**LOWER PROVIDENCE TOWNSHIP
BOARD OF SUPERVISORS BUSINESS MEETING
March 16, 2023**

**Preliminary/Final Plan Major Land Development: LD-22-04 – PJ Land Development-
2619 Ridge Pike Car Wash**

Reference: Tidal Wave Carwash – Technical Stormwater Plan Review
Land Development Application
2619 Ridge Pike

RE: Traffic Review #3 – Transportation Impact Assessment and Preliminary/Final Land Development Plans

PROPOSED SITE PLAN
ADDENDUM TO LAND DEVELOPMENT PLAN
 PREPARED FOR
EVANSBURG WINERY
 3855 GERMANTOWN PIKE
Situate in:
The Township of Lower Providence
Montgomery County, Pennsylvania

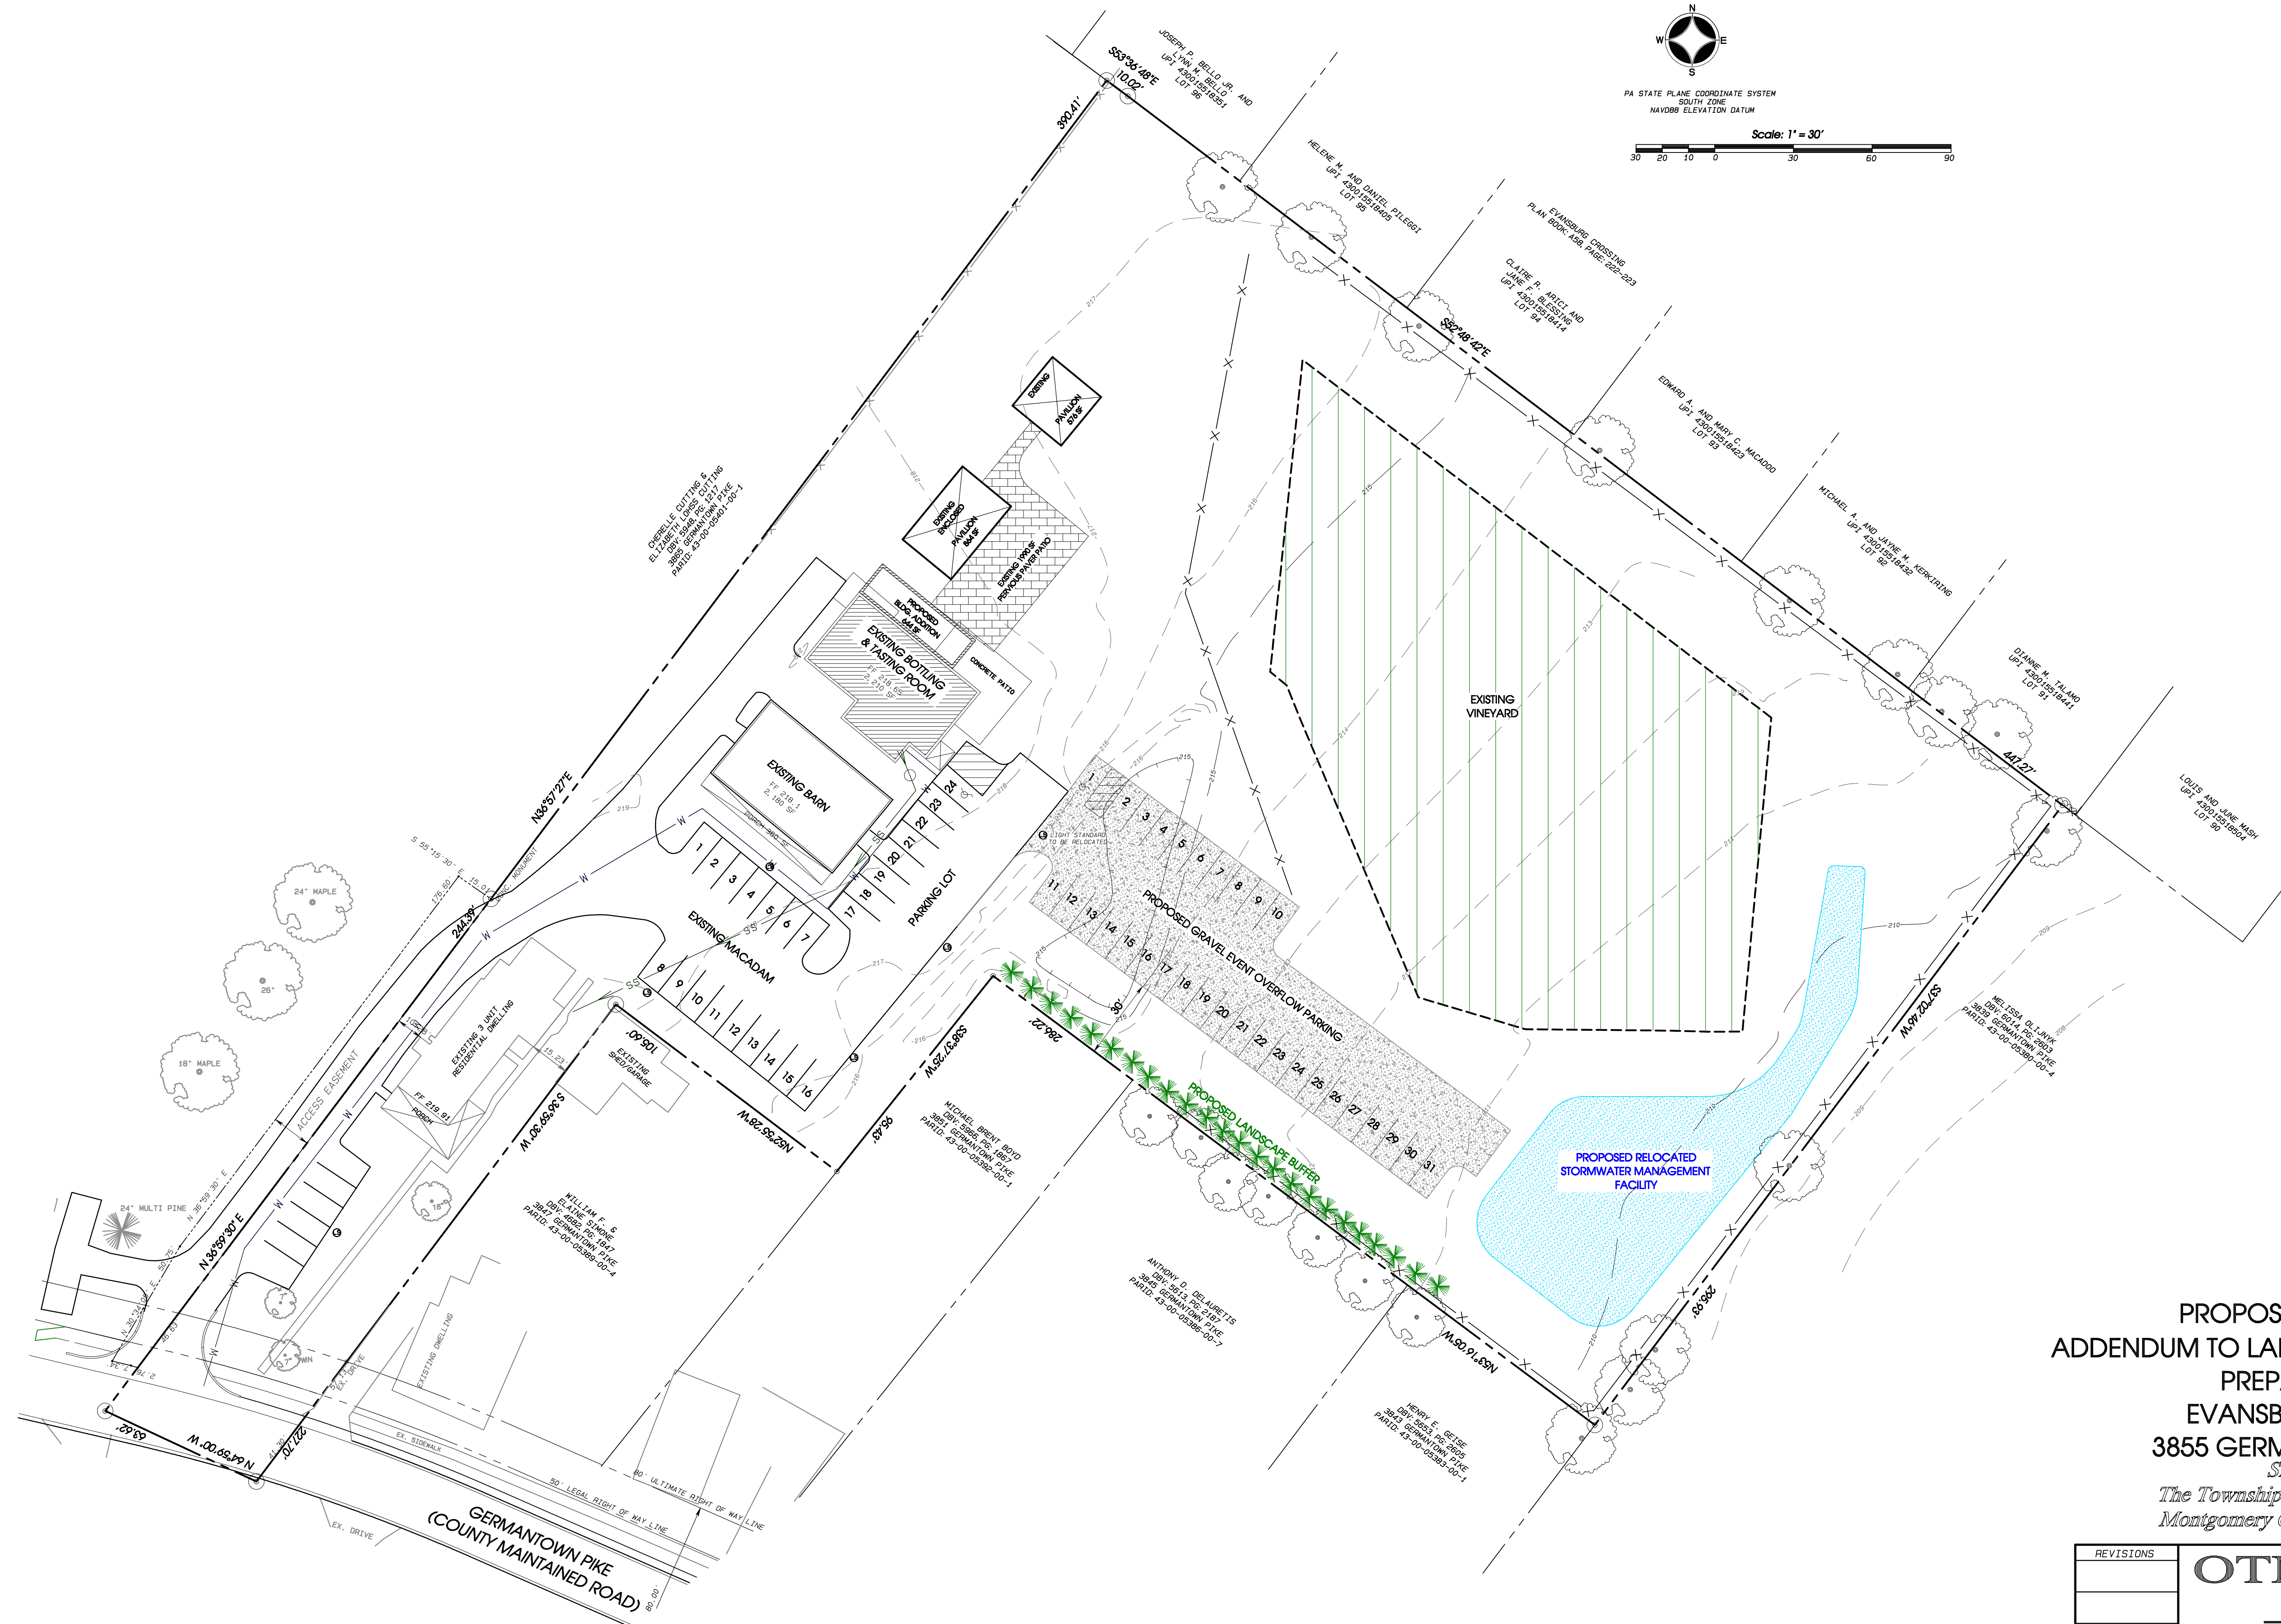
1. The proposed parking lot will disrupt the existing stormwater management facility constructed in conjunction with the original project.
2. The plan submission indicates a potential location for a relocated and improved stormwater facility and controlling not only the existing obligations, but those additive needs caused by the proposed parking lot expansion.

4. The point of discharge of the revised basin will need to be designed to return outflow to a “sheet flow” condition versus any form of point source discharge.

5. Any consideration made by the Board of Supervisors must be conditioned upon a full design of stormwater management facilities, grading plans, erosion control plans, lighting plans and enhanced landscape screen buffering.

SHEET NUMBER:
C-608

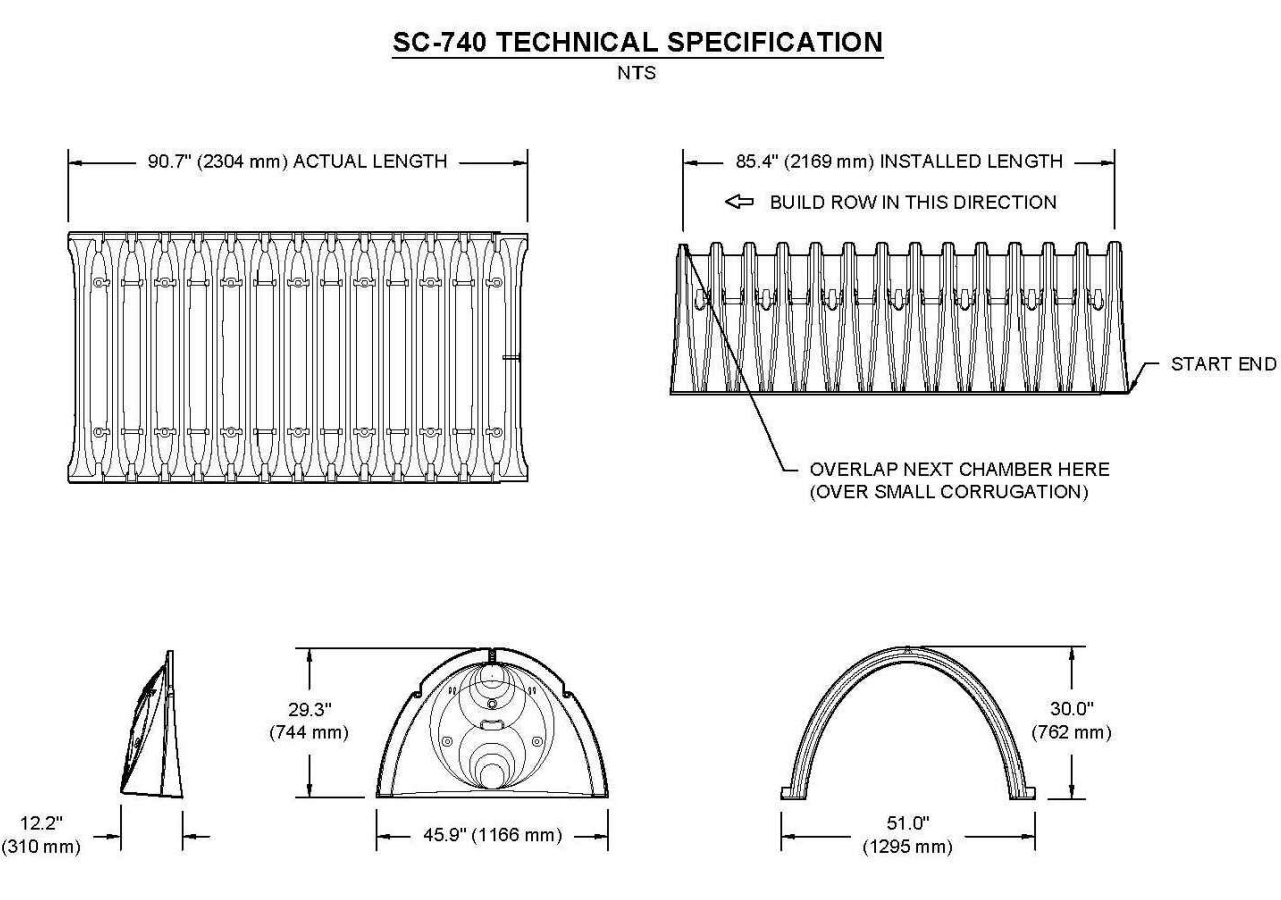
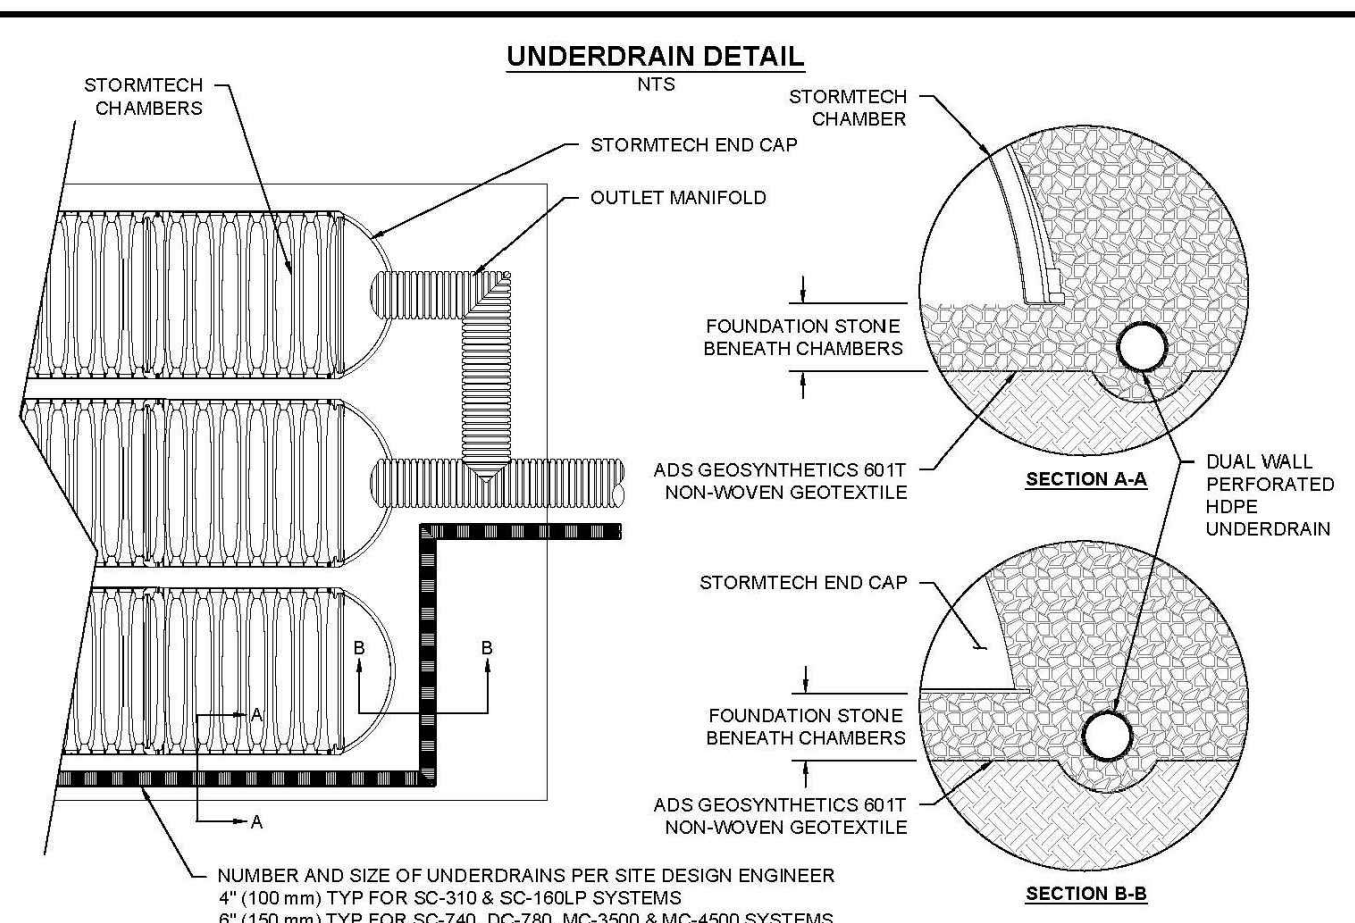
1. The Storm Tech Chamber Cross Section Detail should be revised to reflect elevations for the following:

- Invert of stone on prepared subgrade
 - Invert of chamber system
 - Top of chamber system
 - Top of stone elevation
 - Finish grading elevations atop the system.
2. It is also recommended that a detailed system layout be provided showing the following:
- Length and width of system as shown on Sheet C-607/.
 - Length and width of Overall Basin Area as shown on Sheet C-607.
 - Pipe tie ins and inverts.
 - All Structures and invert information as shown on Sheet C-605.

A-5 BOARD ON BOARD FENCE DETAIL
NOT TO SCALE

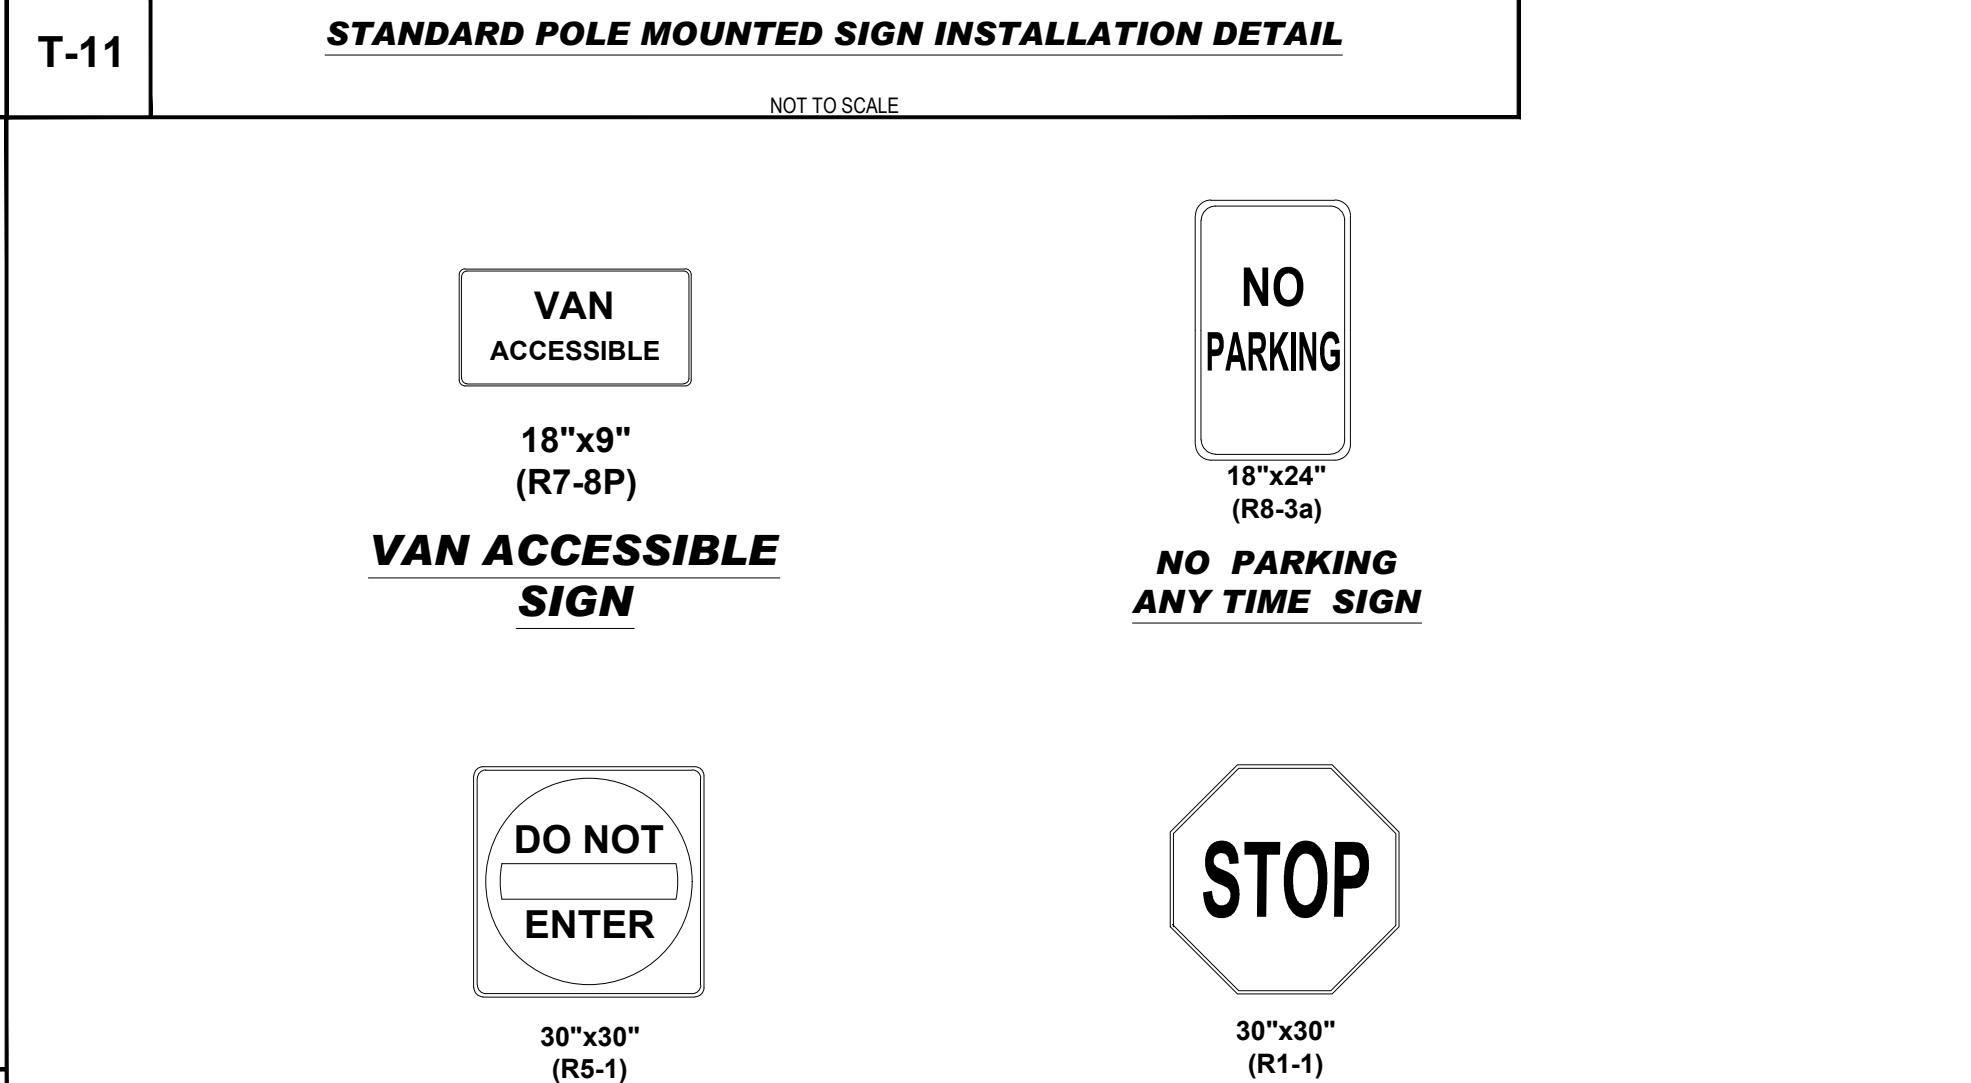
- 2.2. A 5 foot high wood fence is proposed on the eastern property line which abuts R-2 residential. A detail of the fence has been provided on Sheet C-901. Please clarify if the proposed pressure treated lumber will be stained
